17. VISUAL AMENITY ISSUES

17.3. Depiction of dam wall and inundation area

Figure 17-1 : View of top of dam wall and elevation of dam wall

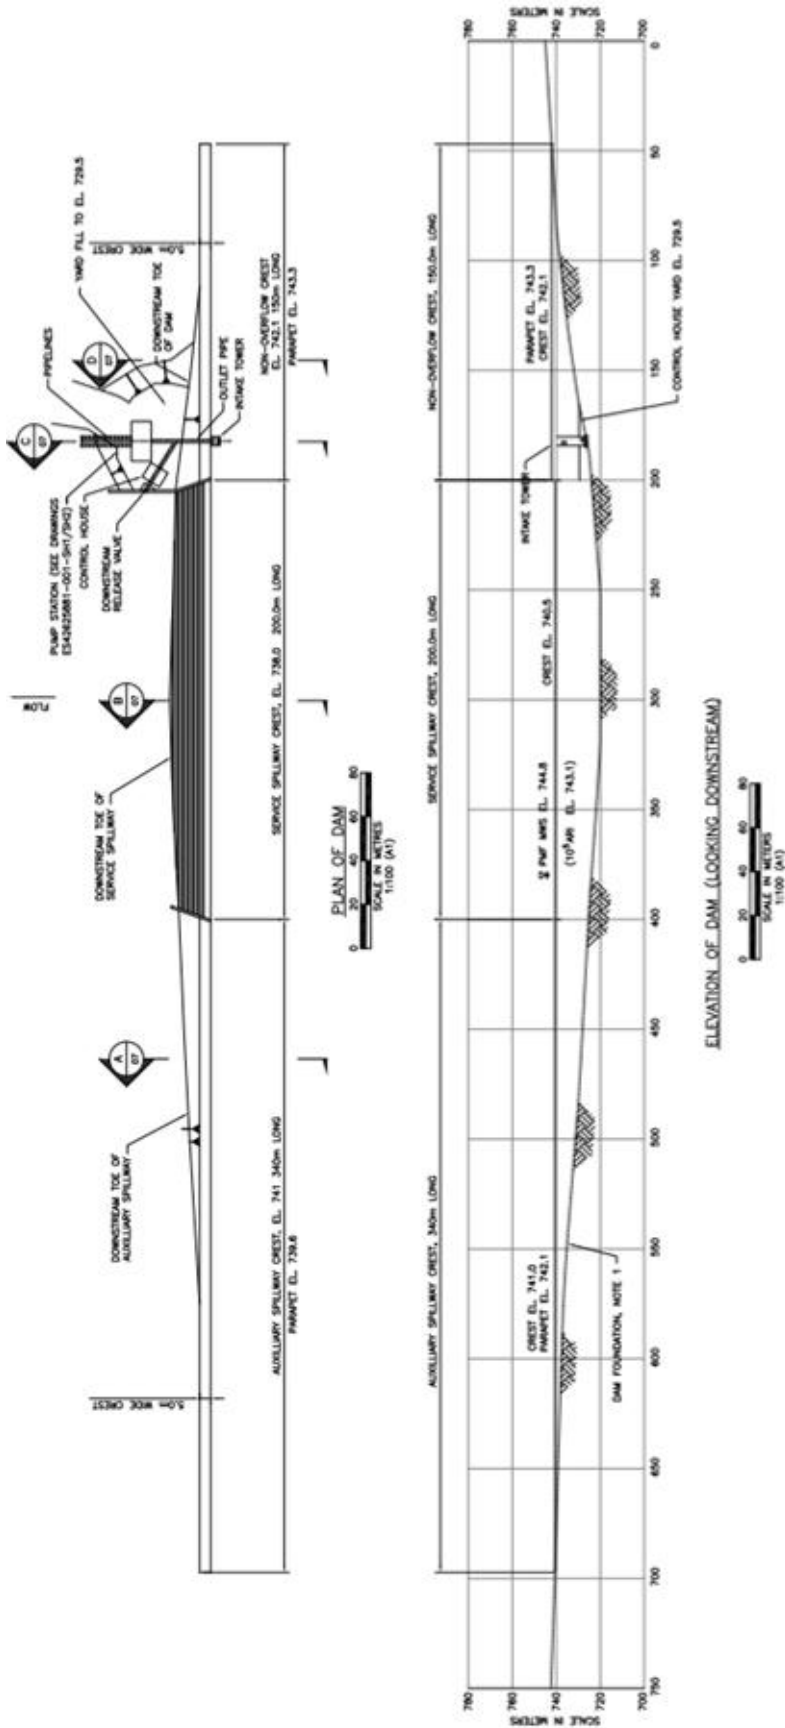
A submission proposed that a depiction of the dam wall structures and impoundment should be provided to allow better evaluation of the assessment of impacts to landscape character and visual amenity. Diagrams of the dam wall are shown in Figure 17-1 and Figure 17-2. The inundation area was shown in Figure 3.1 of the EIS.

In terms of evaluating the impacts of Emu Swamp Dam on landscape character and visual amenity, Section 16.2 of the EIS provided an assessment of potential impacts. This assessment focussed on the most visible elements of Emu Swamp Dam from key sensitive receptors, including the elements shown in the above diagrams. The assessment was based around a clear and detailed methodology of determining levels of impact throughout the visual catchment surrounding Emu Swamp Dam, taking into account a range of variables including topography and vegetation. Based on this detailed methodology of determining visual impacts, a summary of the potential impacts includes:
